**DEVELOPMENT APPLICATION : 9 /2014 PROPERTY: 268-270 Liverpool Road Ashfield FROM : Senior Strategic Planner and Projects**

## SEPP 65 –ASSESSMENT TABLE

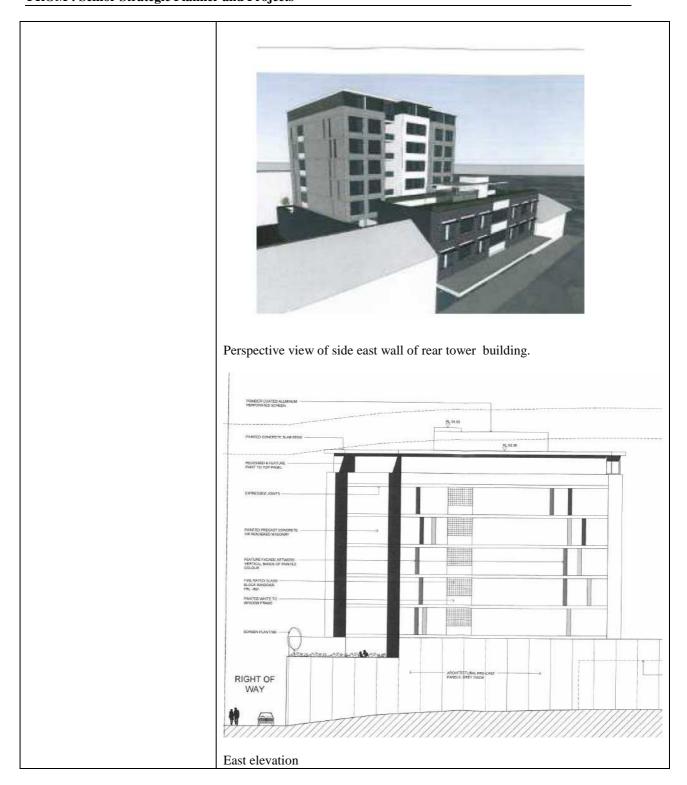
Detailing for component of Liverpool Road facade
Rear Tower Building East Elevation
-
The rear tower buildings have adequate levels of architectural composition. Inevitably, the side wall which are located on the boundary, see perspective below, will be visually exposed until such time as new buildings are constructed on adjacent sites. It is proposed to give "visual relief" to those walls with some glass block surfaces above contrasting painted squares, with vertical painted strips which are differentiated from the painted wall finish background (see similar building treatment below supplied by Architect ), scored horizontal lines, and to have the last storey recessed (according to the proposed elevations) in order to differentiate the "top " from the main body of the buildings. This treatment is considered acceptable, however if the application were approved conditions would have to be for the following:

- Elevations are required to have shadowed surfaces depicted in black
removed in order to make the depiction of the actual building clear. Additional notation is required to describe the grooved lines in terms of depth and width so that they are able to be visually discerned and
<ul><li>"work".</li><li>Floor plans and room layouts of Level 7 (last storey) need to be</li></ul>
amended to show that the eastern and western side walls are recessed from the edge, as claimed on the elevations. Such a recess should be
<ul><li>around 500 mm in order to be effective when seen from a distance.</li><li>A colour scheme needs to be approved by Council for the painted parts</li></ul>
of the building.
ICK VERTICALFACE BRICK O PROPORTIONED FACADE TO S WINDOWS STREET WALL AWNING 
North (Liverpool Road) Elevation

#### Rear Tower Building West Elevation

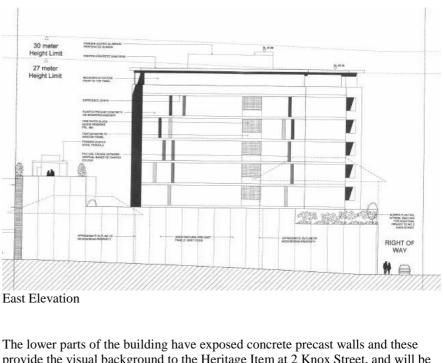
For the west elevation similar comments apply to that explained above for the East Elevation. For the long term, the West elevation will visually exposed from Knox Street, including seen over the top of the building at 2 Knox Street, and between that building and the Mall walls, so it is important to "get the details right" at construction stage.

Ine lower parts of the building have exposed concrete precast walls and these provide the visual background to the Heritage Item at 2 Knox Street, and will be also seen when viewed by pedestrians from a street position between the 2 Knox Street building and the Mall walls. The proposal should therefore be conditioned to provide an attractive visual treatment to those walls on the boundary with 2 Knox Street. Given these are boundary walls, any treatment will need to be long lasting and needs to be more than a painted decorative finish.
